# SERVICE BULLETIN # 00169

**SUBJECT:** Acceptance problem with tokens or larger coins

**MODELS:** All GIII Venders with EVS-2 software (PO # 1478 to 1504)

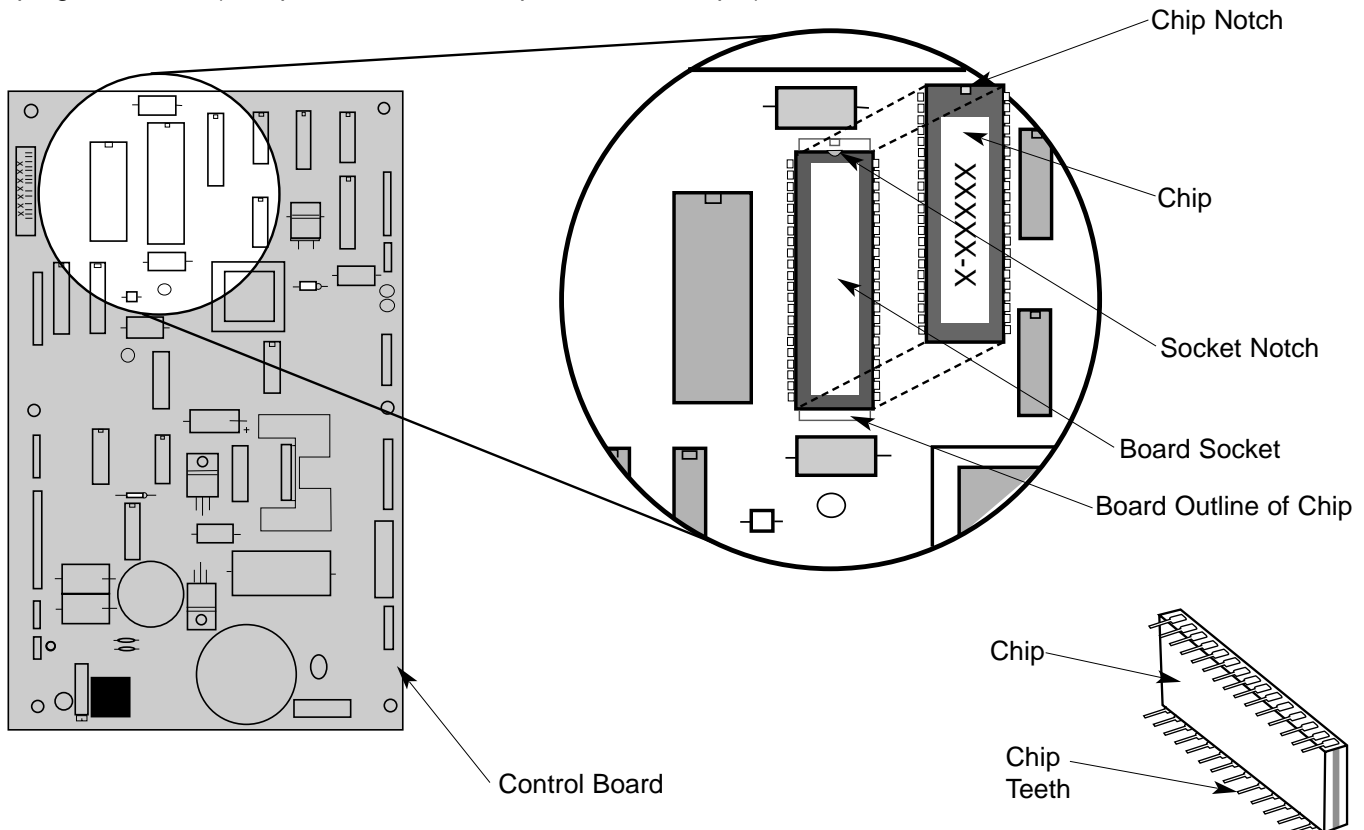
This applies to GIII venders with E.V.S. software which are demonstrating erratic acceptance of tokens or larger coin types (8-15). Changers have the ability to accept 16 different coin types 0-15 (0 being the smallest denomination and 15 being the largest denomination). If you have EVS 67121-2 chip or EVS 67122-2 and are having an acceptance problem with tokens or larger coin types; the above chips will solve this problem for all G-III venders with EVS software.

Part Number	Part Description	Countries
836117	67121-3 or higher EVS Chip	U.S., Canada, Mexico, Peru, Holland, France, Ireland, Brazil, Finland, Belgium, Bolivia, Uruguay
836118	67122-3 or higher EVS Chip	Australia, New Zealand, Denmark, South Africa, U.K., Singapore Chile, Argentina

1. Remove power from vender by unplugging vender's main power cord from the AC voltage power source (wall outlet)
2. Using a chip extractor (or small screwdriver) remove 67121-X or 67122-X chip.
3. Position the new chip by aligning the chip notch with the socket notch of the control board.
4. Insert the right-side teeth of chip into the board socket, then push chip slightly to the right until the left-side teeth line up with the board socket, then push the chip into the board socket.
5. Make sure all chip teeth are inserted into the board socket.
6. Reprogram vender (i.e. space to sales, vend price, column depth).
